PLAT COMMITTEE

Case Number: 2026-PLT-042

Request: Approval of two Subdivision Plats, to be known The Trees at Southport Crossing Section 2A/2B and The Trees at Southport Crossing Section 3, dividing 27.5 acres into 67 lots, with a waiver of maximum number of two local streets used by emergency vehicles requirements for Section 2A, per Chapter 741, Article III, Section 3.B of the Consolidated Zoning and Subdivision Ordinance.

Staff Reviewer: Michael Weigel, Principal Planner I

2026PLT042 ; Preliminary Plat (Section 2A/2B ; 1 of 3)

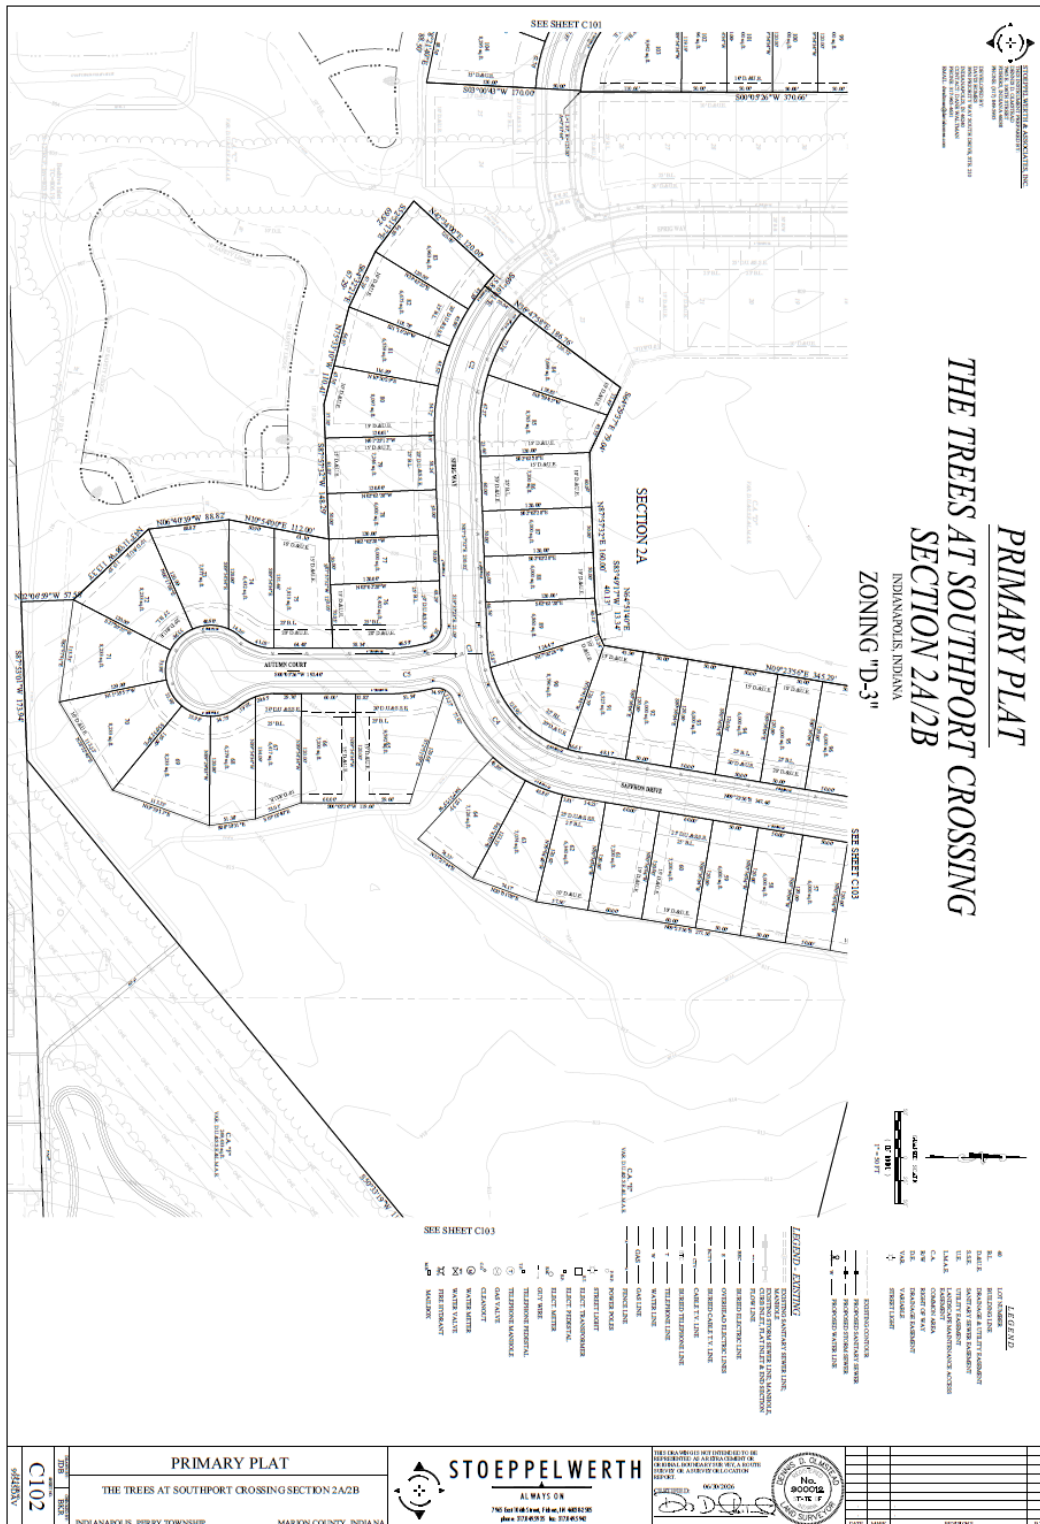
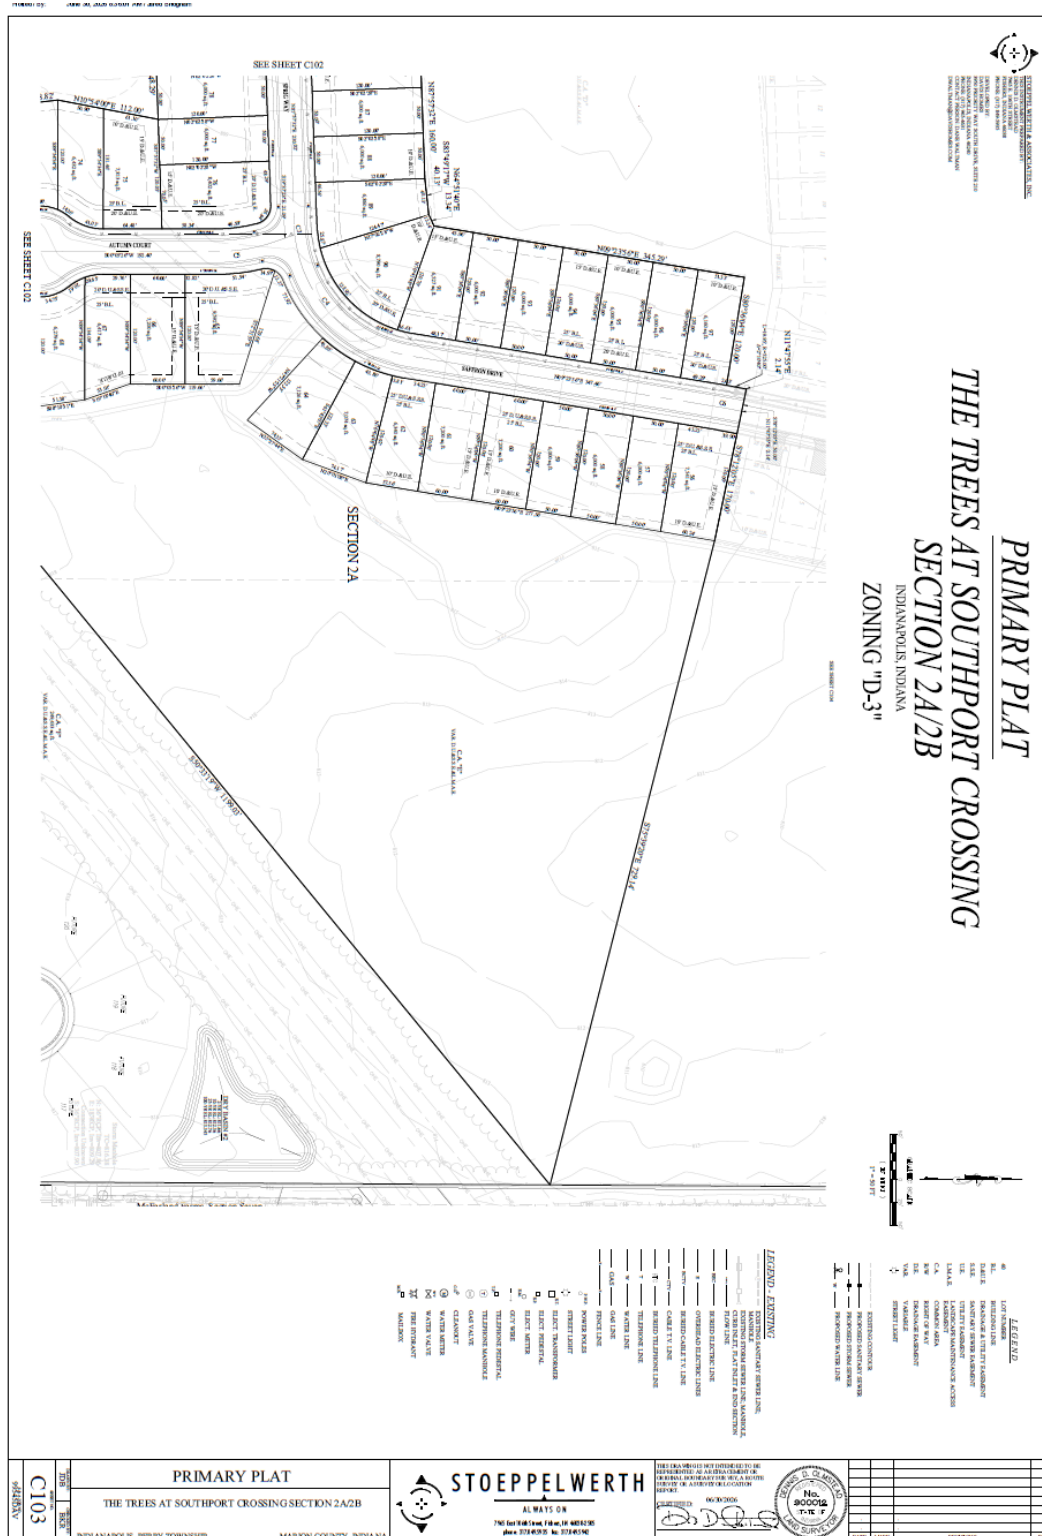
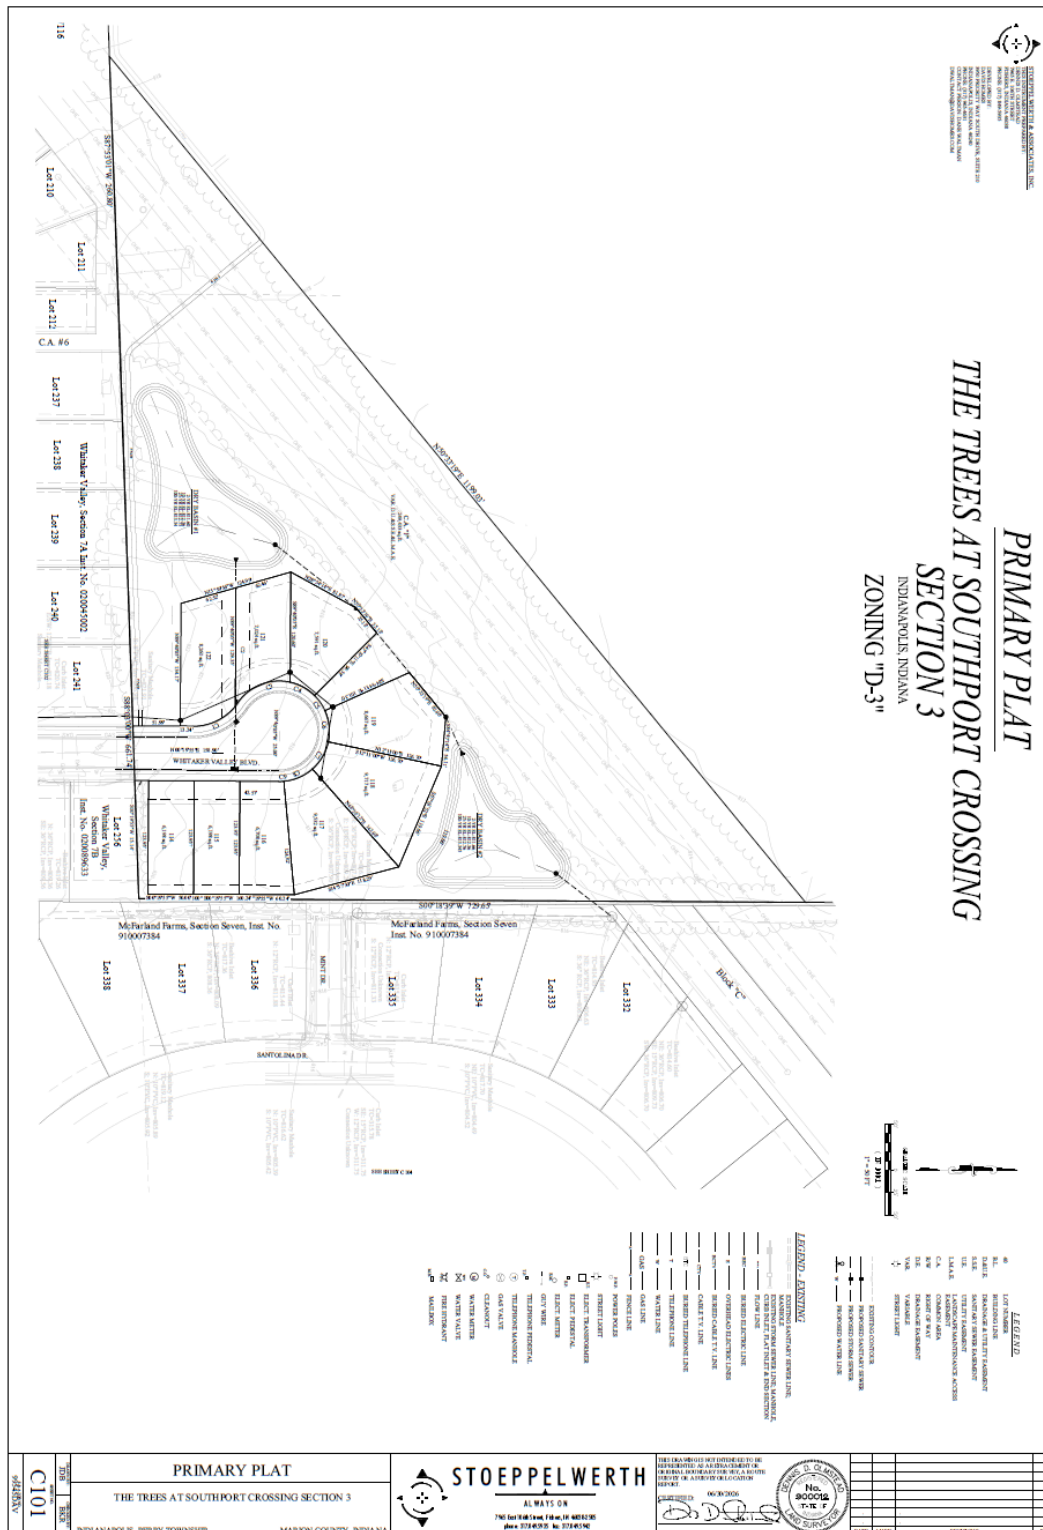
The Ordinance specifies that emergency vehicles must not have to use more than two different local streets to reach any destination lot. The site is accessed via several local streets within existing development in all directions. Stop 10 Road directly accesses Sherman Drive (a primary collector street) to the west. The waiver would only be required for the cul-de-sac Autumn Court, which would offer an adequate turn radius and access (per an Indianapolis Fire Department Representative) and would only impact 11 of the 132 lots within the subdivision. Therefore, this would be a minor deviation from Ordinance requirements and staff would recommend **approval** of the waiver request.

8. That the Sanitary Sewer Covenant (Section 741-704, of the Consolidated Zoning and Subdivision Ordinance) be affixed to the Final Plat prior to recording.
9. That the Storm Drainage Covenant (Section 741-703, of the Consolidated Zoning and Subdivision Ordinance) be affixed to the Final Plat prior to recording.
10. That the plat restrictions and covenants, done in accordance with the rezoning commitments, be submitted prior to recording the Final Plat.
11. That all the standards related to Secondary Plat approval listed in Sections 741-207 and 741-208 of the Consolidated Zoning and Subdivision Ordinance be met prior to recording the Final Plat.
12. That the requested waiver of maximum number of local street used by emergency vehicle requirement, per Chapter 741, Article III, Section 3.B of the Consolidated Zoning and Subdivision Ordinance, be **approved**.
